# Avolites Ltd. Engineering Change Notice

<b>Title</b>	Diamond 4 LBA modifications
<b>ECN Number</b>	ECN-0158
<b>Equipment</b>	Diamond 4 Vision and Elite
<b>Author</b>	Adam Proffitt and Robert Henry
<b>Date</b>	31/03/05

<b>Reason for ECN</b>	Occasional noise from screen brightness control potentiometer - can be detected from usb panel packet counter. Problem affects playback faders
<b>Special Parts required</b>	None
<b>Special Tools required</b>	None

### LBA Revision A Board Modifications

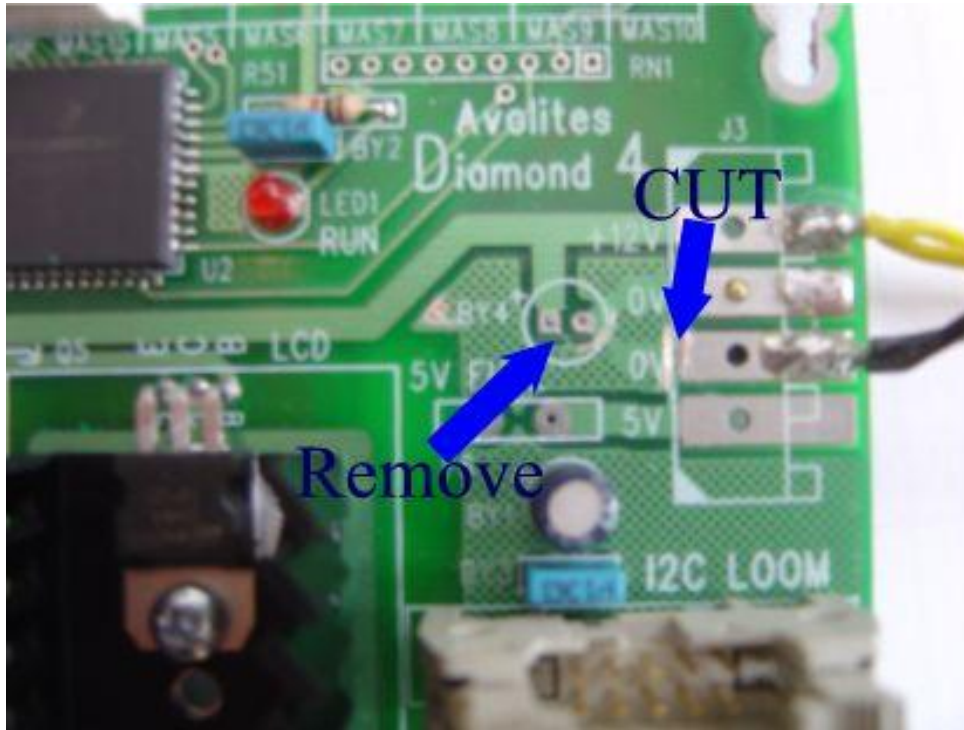
**Note:** These boards already have 2x10nF capacitors fitted between pins 2&3 of MAS1 and MAS2 (as shown in solder side of photo below).

**Note:** Revision B boards Do not require any modifications except for the removal of BY1&4.

The modifications separate the 0V supply for the dimmed outputs from the 0V supply which is fed from the 10way IDC connector.

1. Cut track near 0V supply cable on component side of board.
2. Remove capacitor BY4.

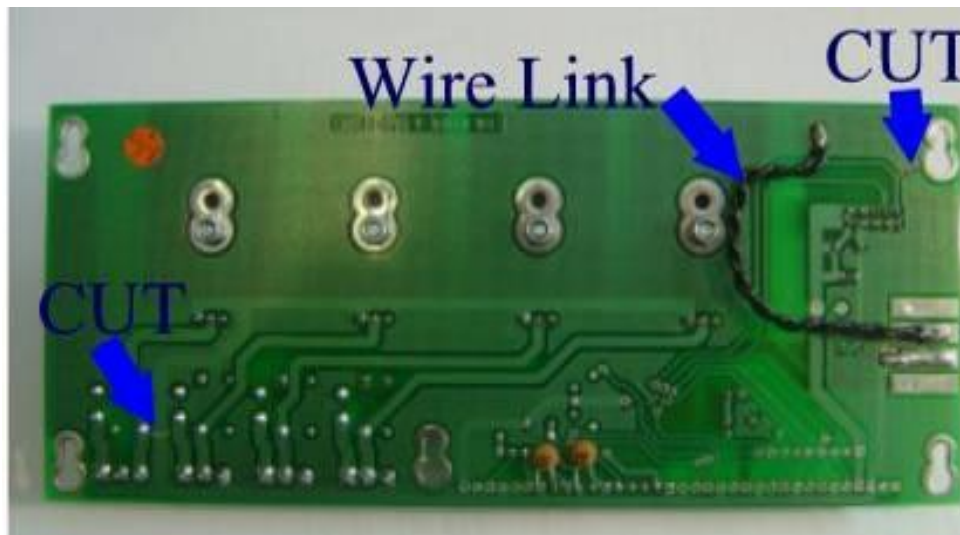
3. Cut 2 tracks on solder side of board.
4. Scrape the surface of the 0V plane and add 2x16x0.2mm link wires (twisted together) from 0V supply to 0V plane as shown in photo overleaf.

5. Solder the supply cables (yellow and black) as shown in top photo. Note that the 0V supply cable is on the pad directly above the wire link.
